Access Compliance Report Public Rights-of-Way (Curb Ramps)

Main Street: CHRISTY_LN Cross Street: KEMPTON_DR Location: NE

ADA ID: RPRK211221125634 Ramp Type: Type 1 - Perpendicular Diagonal Initial Pass/Fail: Pass Overall Compliance: No Severity Score: 12

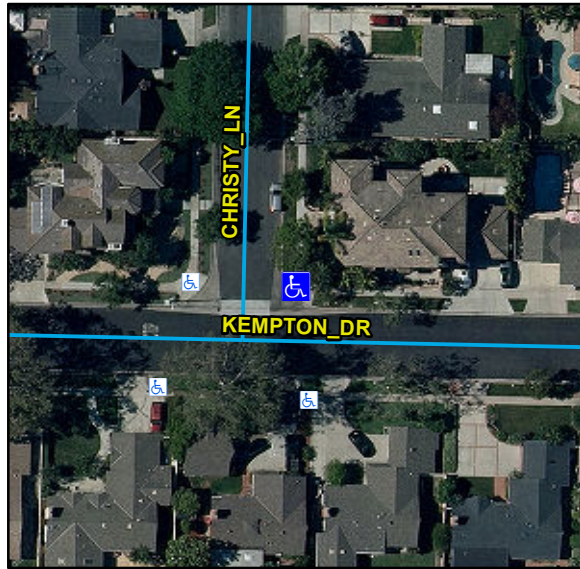
R204.3, R304.2.2-Perp, R304.3.2-Para, R305, R302.7, R302.7.2, STD 1115

Remove & Replace Curb Ramp With Two New Directional Ramps or Equivalent. Grind Gutter Lip.
